**Comments from Lumination**  
**“ENERGY STAR Program Requirements**  
**for SSL Luminaires – Category “A” Additions**

Figure 1

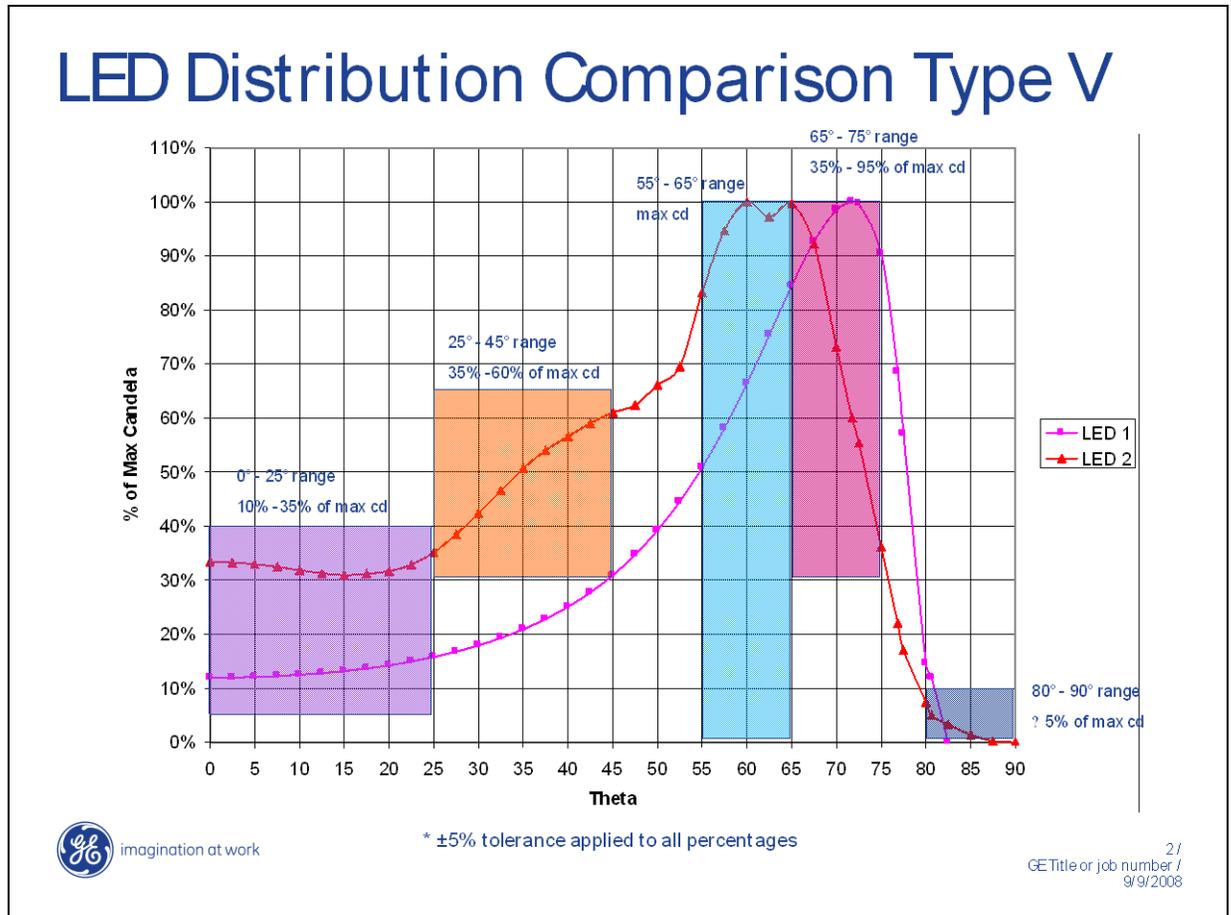
As an example, **Figure 1** provides a comparison of an LED-based Site Light solution that was optimized for “light usage”, uniformity and minimum glare (LED1); whereas LED2 was designed to mimic the existing HID light output profile. Note that LED2 would meet the proposed Zonal Density specification (as identified by the colored “blocks”); whereas, LED1 would not.

Figure 3

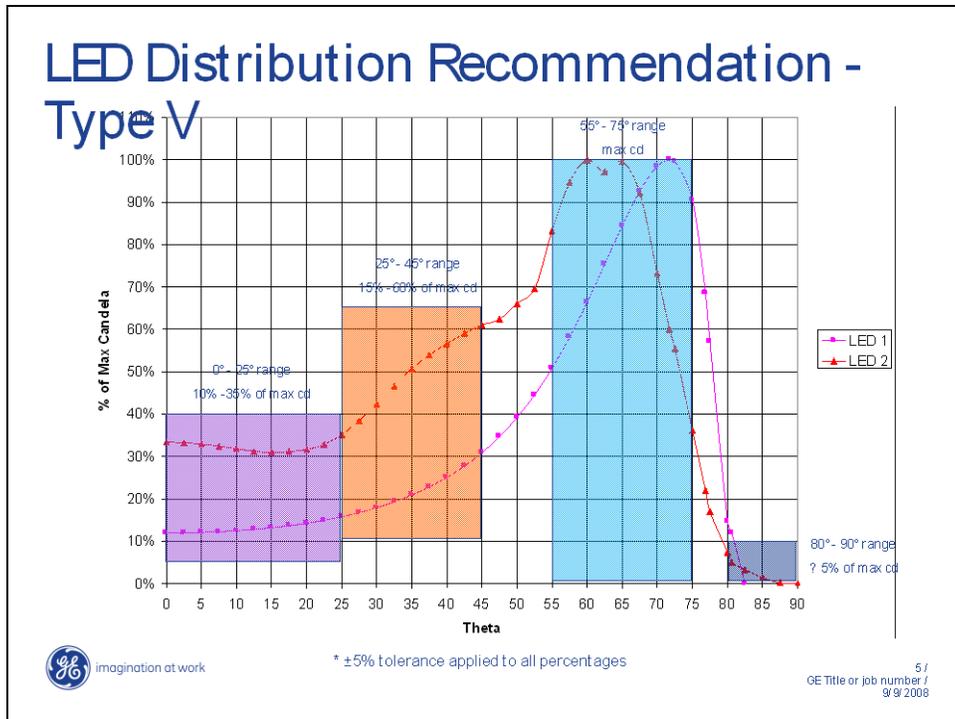
In **Figure 3**, a comparison of the power consumption, Lumen efficacy, minimum intensity and Max/Min ratio for the two lamps demonstrated in Figure 1 clearly shows the benefits of a “non-HID” type of profile. Although the total flux is ~20%

lower for LED1, the minimum maintained intensity is 1.77X that of LED2! And both solutions meet the proposed Energy Star criteria for luminous efficacy. In addition, glare reduction is significant in the LED1 design and has garnered very positive feedback in the marketplace.
